Specification Mintech./CV2362 - CV2368
 Issue 2A, Dated September 1967
 To be read in conjunction with K1001
 ignoring clauses:- 5.2, 5.3, 5.8.

Type of Valve:- Magnetron
 Cathode:- Indirectly heated
 Envelope:- Metal glass
 Prototype:- M525

AMENDMENT No.1

ELECTRONIC VALVE SPECIFICATIONS
SPECIFICATION MINTECH/CV2362 - CV2368,
ISSUE 2A, DATED SEPTEMBER 1969
AMENDMENT NO 2

Page 6

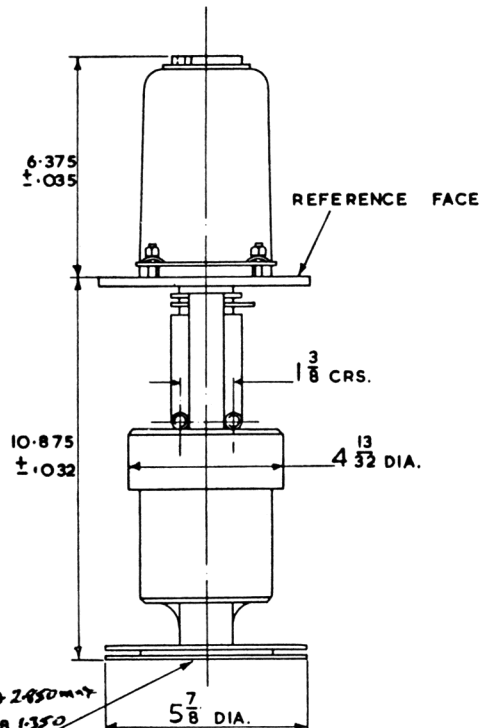
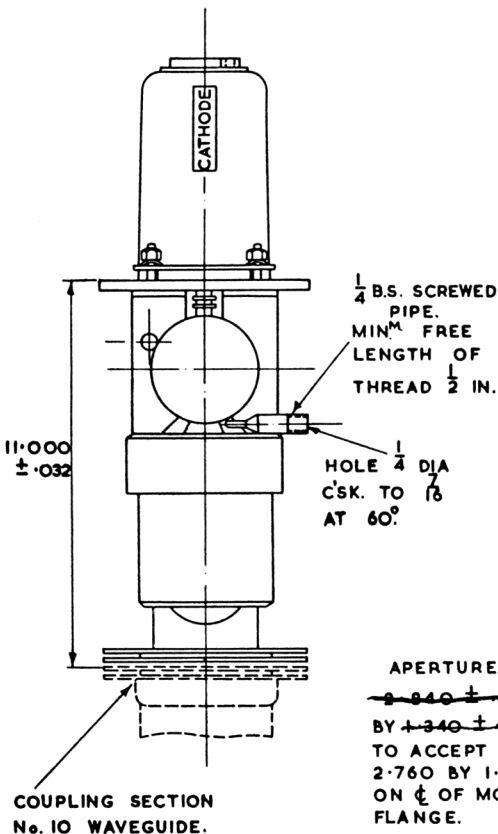
Page 5. Outline Drawing.

View in top right hand corner.

The flange diameter is shown as "6.000 Dia + .000"
- .000
which should be amended to read "6.000 Dia + .000"
- .010.
